EVALUATION OF TWO NEW CENTERMELT FUEL ASSEMBLIES FOR BIG ROCK POINT
NUCLEAR REACTOR (CONSUMERS POWER COMPANY)INTRODUCTION

Change No. 24
License No. DPR-6

CHANGE NO. 24 TO TECHNICAL SPECIFICATIONS

FIGURE 8.6 NEW INTERMEDIATE PERFORMANCE FUEL CENTERMELT ASSEMBLY (8x8 ARRAY)

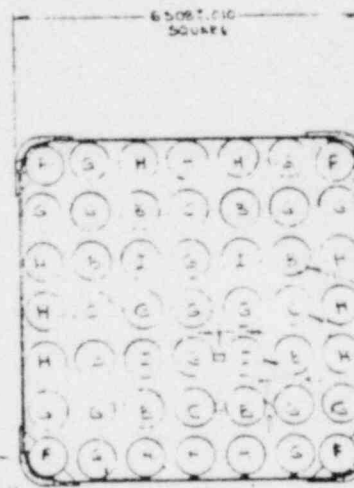
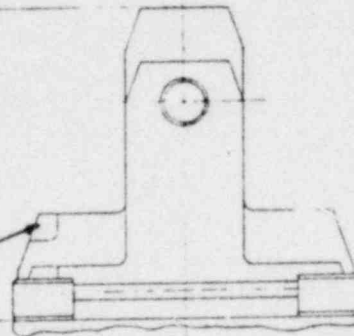
Add Figure 8.6 - New Intermediate Performance Fuel Centermelt Assembly (8 x 8 Array) and Figure 8.7 - New Advanced Performance Fuel Centermelt Assembly (7 x 7 Array).
